July 7, 2022

Leimac Ltd.
LED Lighting Group
Sales Department
TEL : +81-77-585-6771
FAX : +81-77-585-6773

Notice of discontinued product (IDDA-KH series)

IDDB-KH60□

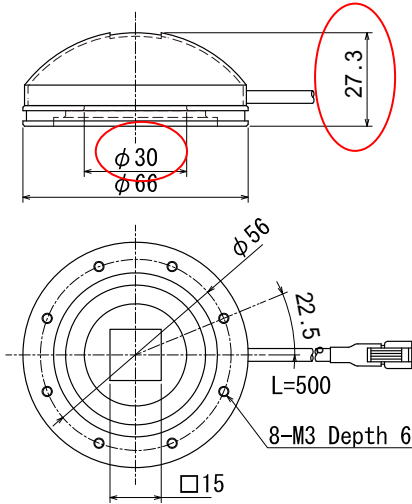
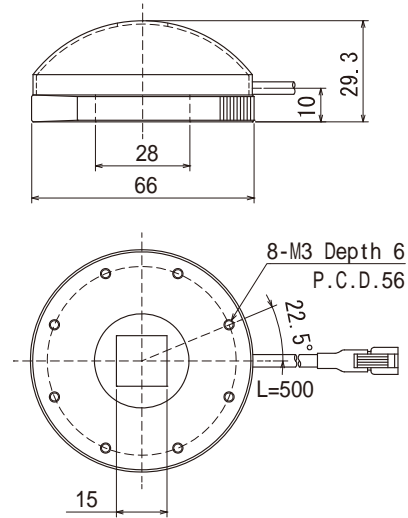
Although the case shape has been changed, the mounting pitch and outer diameter dimensions are the same.

Weight : 90g

Weight : 120g

IDDB-KH80□

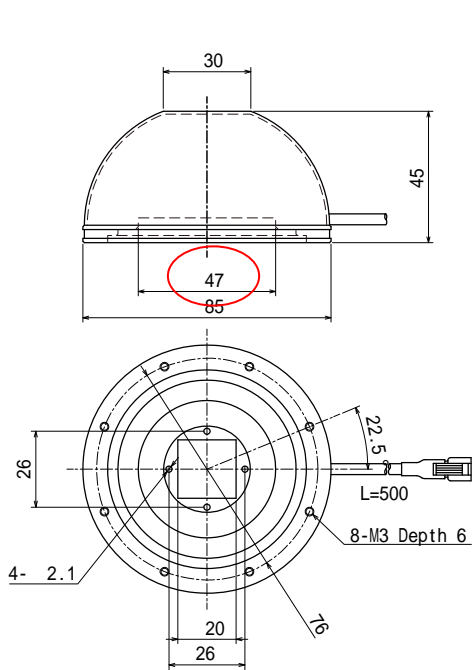
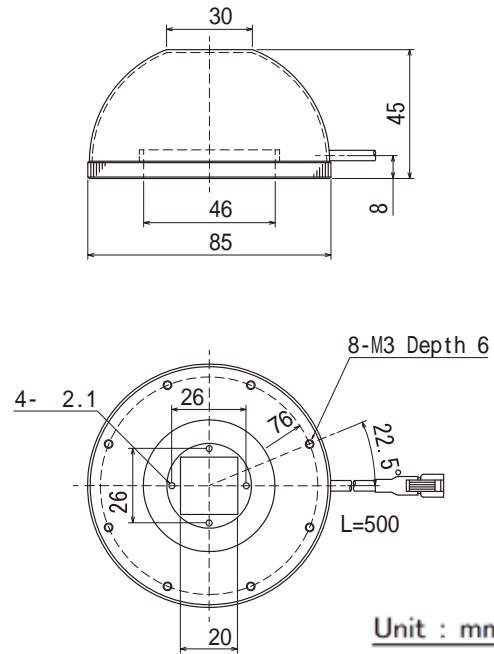
Weight : 105g

Weight : 150g

< New Product >
IDDB-KH120□
Weight : 195g

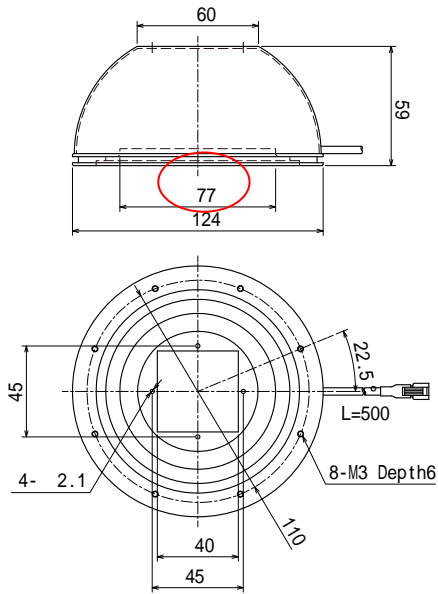
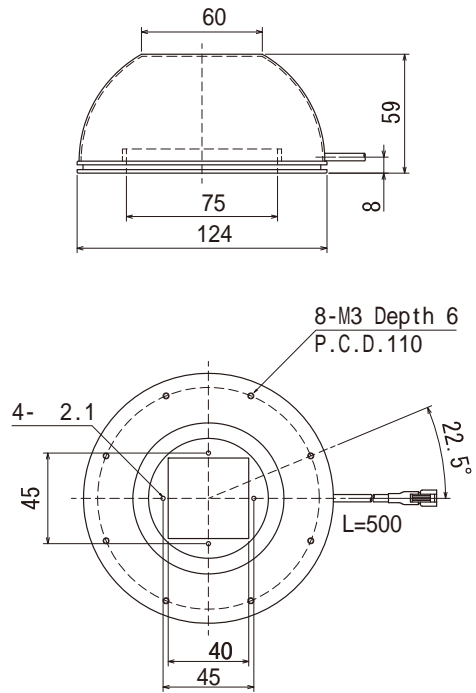
< Discontinued Product >
IDDA-KH120□
Weight : 305g

IDDB-KH150□
Weight : 260g

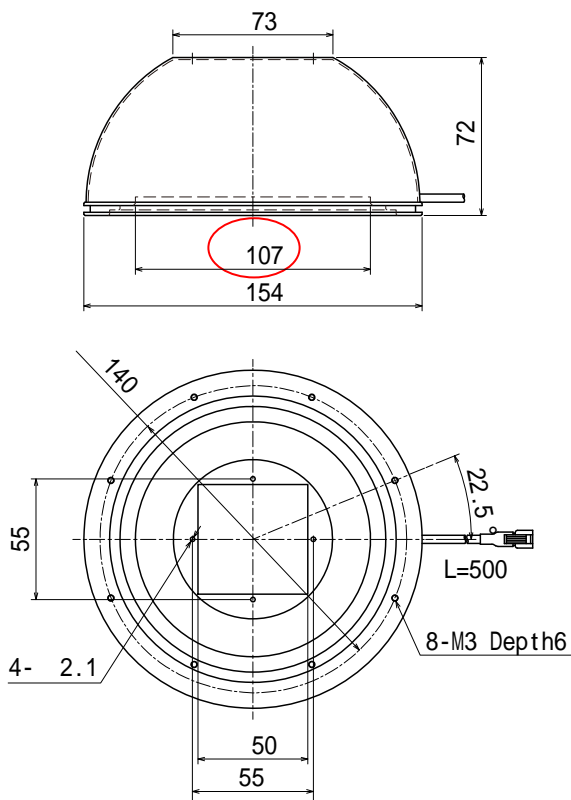
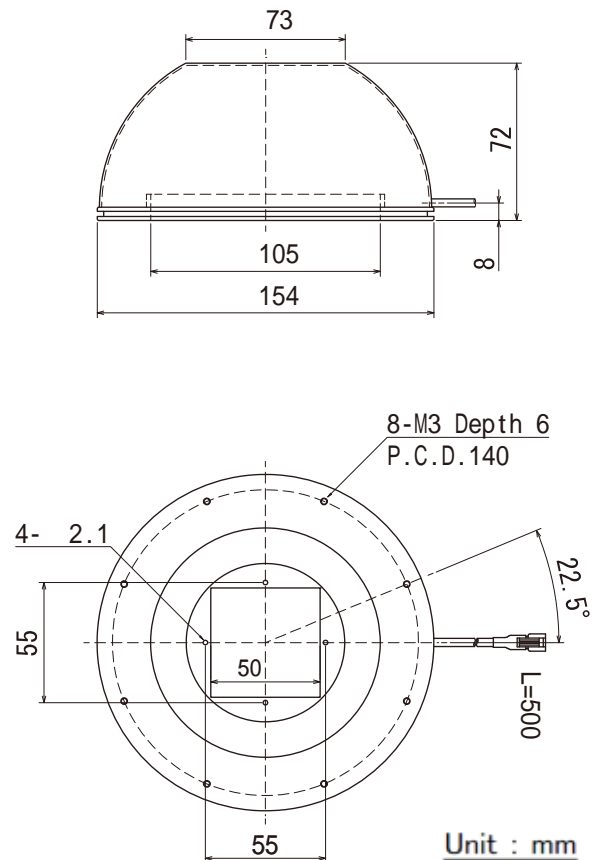
IDDA-KH150□
Weight : 415g

< New Product >
IDDB-KH220□
Weight : 455g

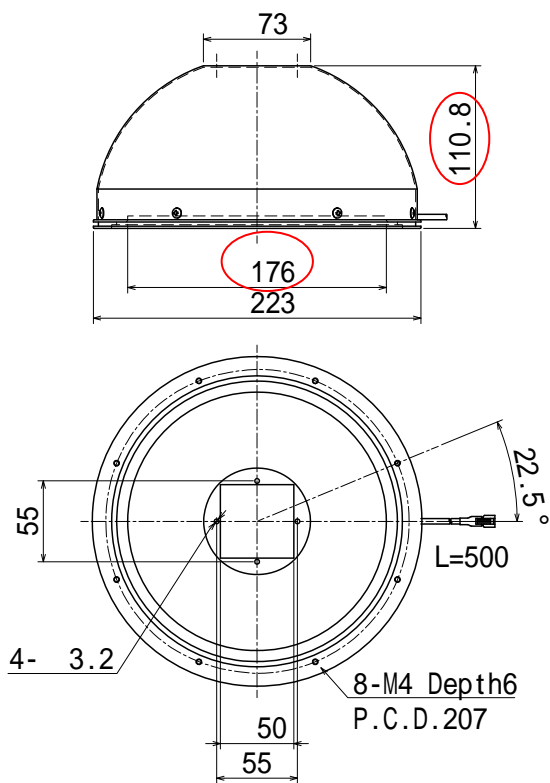
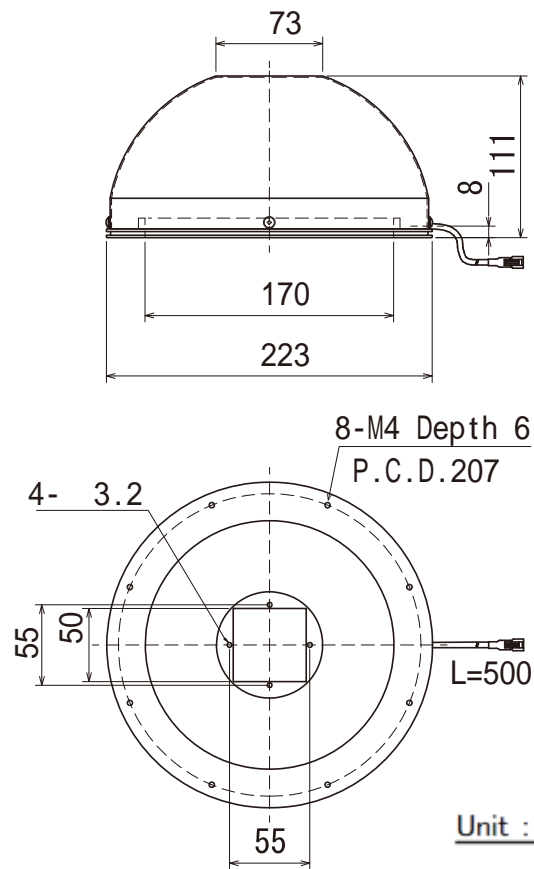
< Discontinued Product >
IDDA-KH220□
Weight : 765g
